Proposal for the 10 series of amendment to UN Regulation No. 107 (General construction M₂ & M₃)

Submitted by the experts of the Informal Working Group on Behaviour of M₂ and M₃ vehicles in case of Fire Event*

"Figure 32

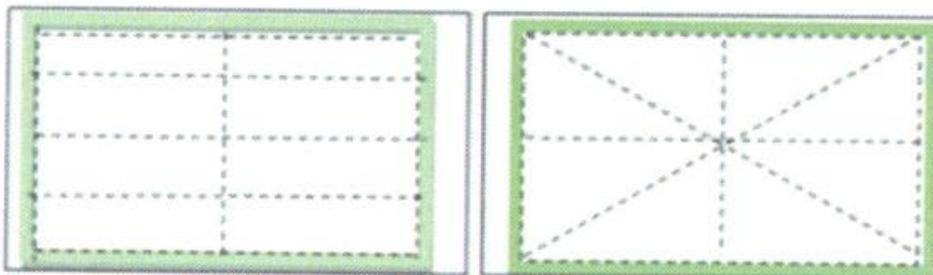
- 7.6.9.5.3.4.** The ~~inner~~ surfaces of each escape hatch may be fitted with a plastic film to enable the person to remove the window pane or panes ~~with his hands~~. The plastic film shall be cut at the outer edge of the emergency window and following the ~~a~~ patterns as e.g. shown in Annex 4, Figure 32. In case of fitting a plastic film to the emergency exit, it shall be compatible with the device ~~for breaking the glass~~ and shall not reduce its efficiency. In addition, the characteristics of the approved glazing shall remain unchanged."

Annex 4, after Figure 31 insert:

Patterns for cutting plastic film on emergency window or escape hatch

(See Annex 3, paragraphs 7.6.8.2.2.4. and 7.6.9.5.3.)
